**CITY OF LOS ANGELES**  
INTER-DEPARTMENTAL CORRESPONDENCE

1187 W Sunset Blvd  
DOT Case No. CEN23-54959

Subject: **TRANSPORTATION ASSESSMENT FOR THE PROPOSED RESIDENTIAL PROJECT LOCATED AT 1187 WEST SUNSET BOULEVARD (PAR-2023-1159-AHRF/ENV-2023-5529-SCEA)**

CONCEPTUAL SITE PLAN  
PROJECT SUMMARY

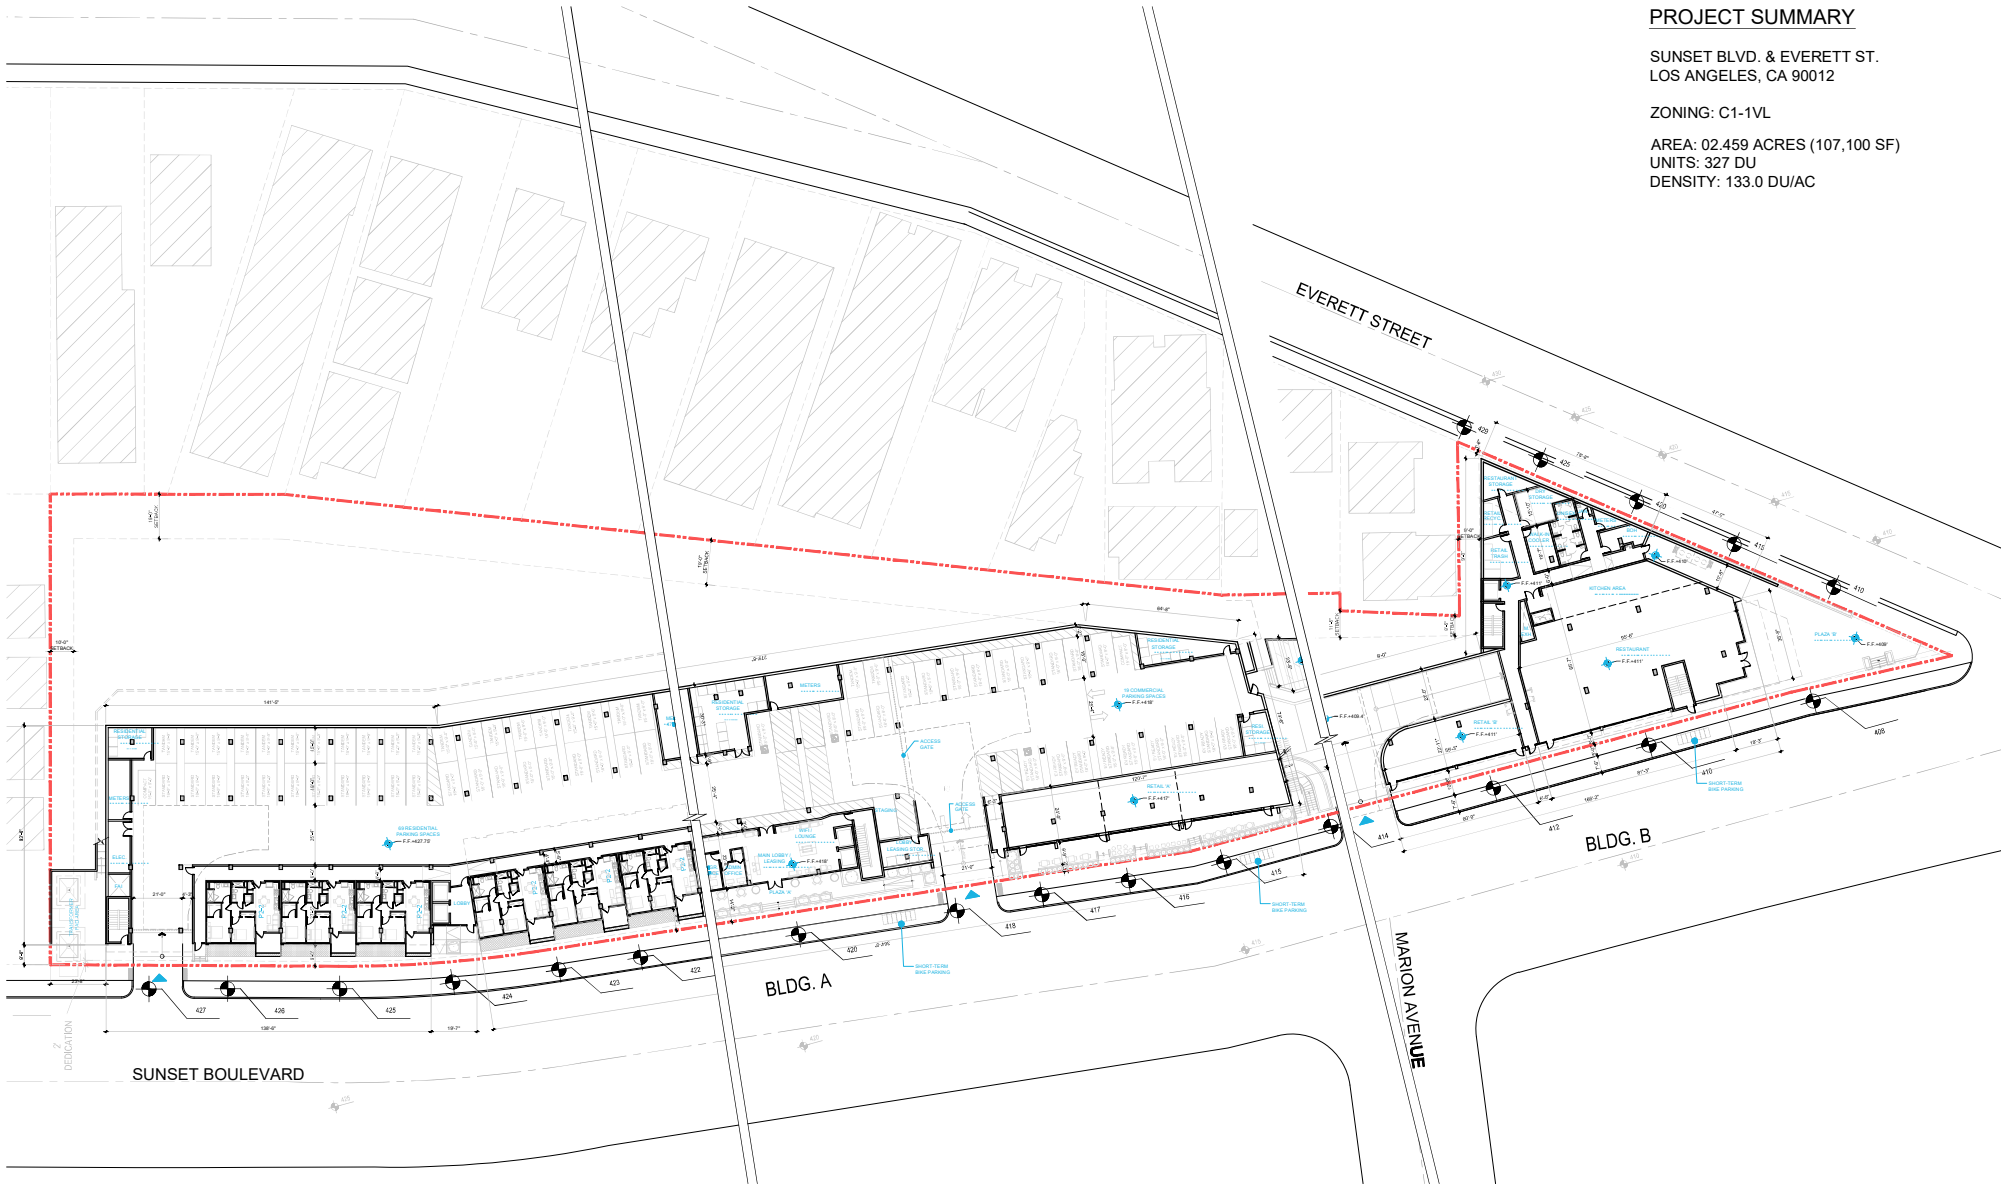
The conceptual site plan for the project (see **Attachment A**) is acceptable to LADOT. Residential access will be provided via three driveways along Sunset Boulevard north of Everett Street. The north and middle driveways will provide left/right-in and right-out access, and the south driveway will provide full access. Review of this study does not constitute approval of the dimensions for any new proposed driveway. Review and approval of the driveway should be coordinated with LADOT's Citywide Planning Coordination Section <ladot.onestop.@lacity.org>. In order to minimize and prevent last minute building design changes, the applicant should contact LADOT for driveway width and internal circulation requirements prior to the commencement of building or parking layout design. The applicant should check with City Planning regarding the project's driveway placement and design.
